UNITED STATES  
NUCLEAR REGULATORY COMMISSION  
WASHINGTON, D. C. 20555

APR 29 1975

E 11-  
POOL DYNAMIC LOADS ON MARK I CONTAINMENTS

FIGURE 2. MARK I TYPICAL VENT SYSTEM ( BROWN'S FERRY)

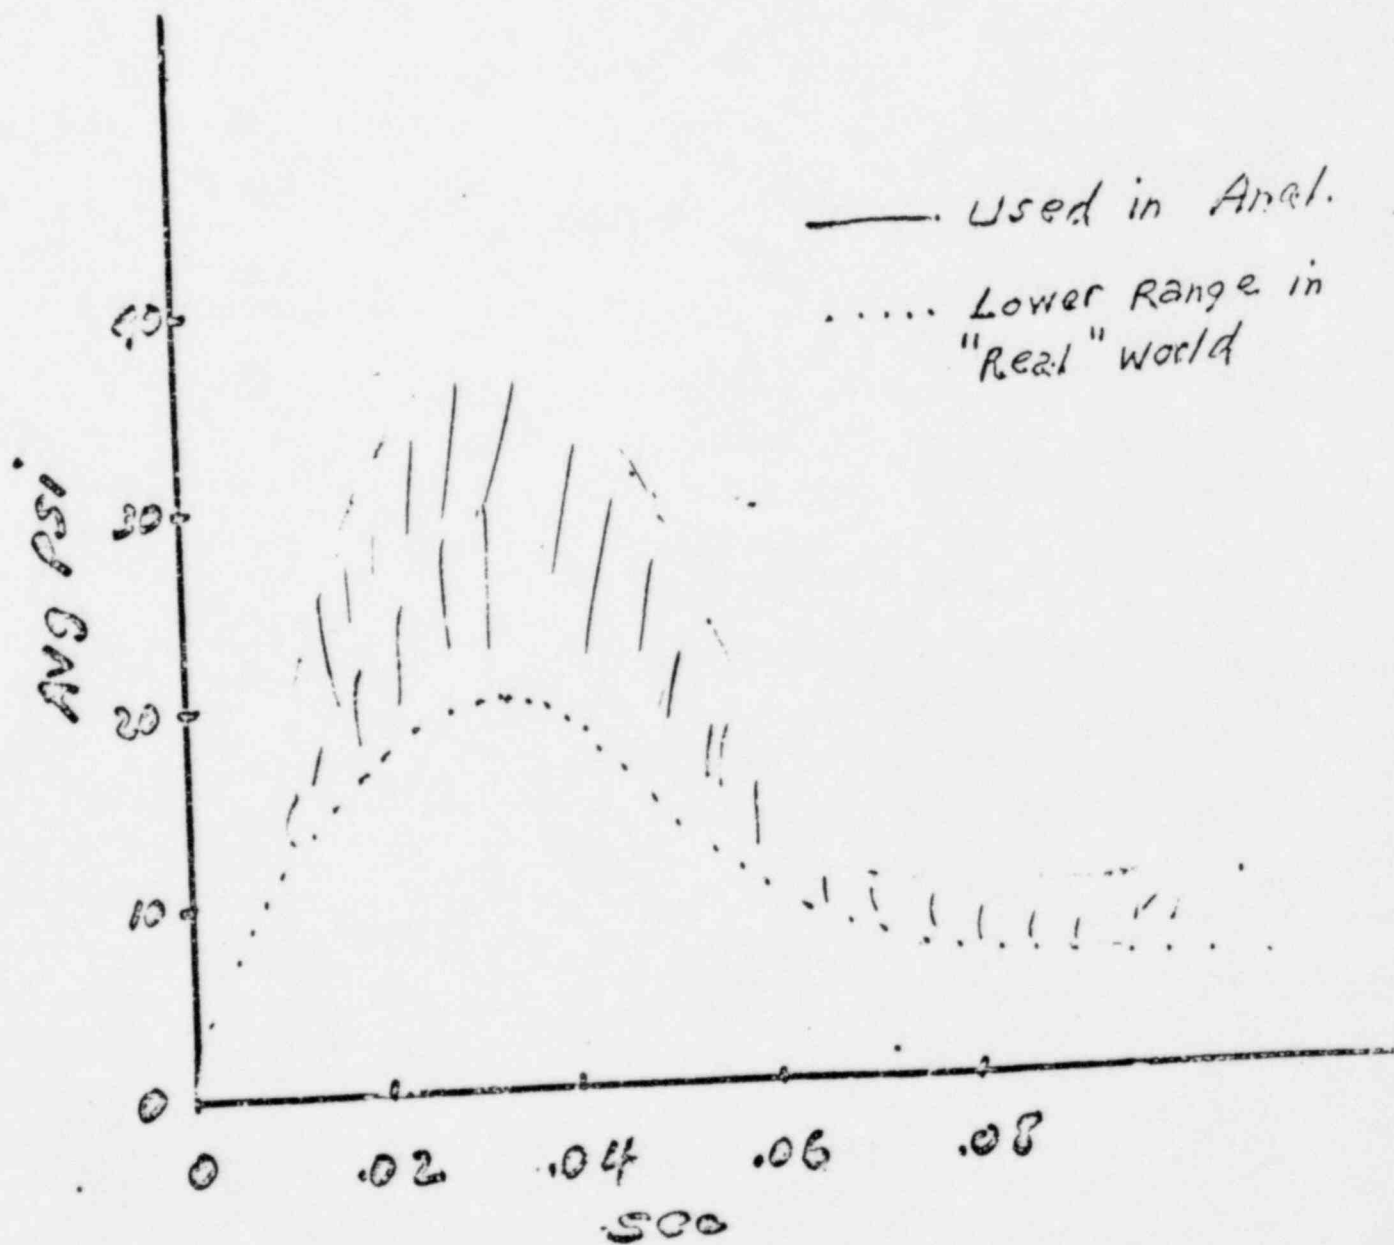
GE has completed a preliminary structural analysis for a typical Mark I configuration (Browns Ferry) and arrived at a preliminary conclusion that the loss of containment integrity will not occur. However, the preliminary analysis indicated that local yielding will occur in the clevis support of the ring header. Accordingly, GE has started a detailed structural analysis of the ring header and its clevis supports to determine the extent of any yielding, its potential effects on containment integrity, and the need for any backfitting.
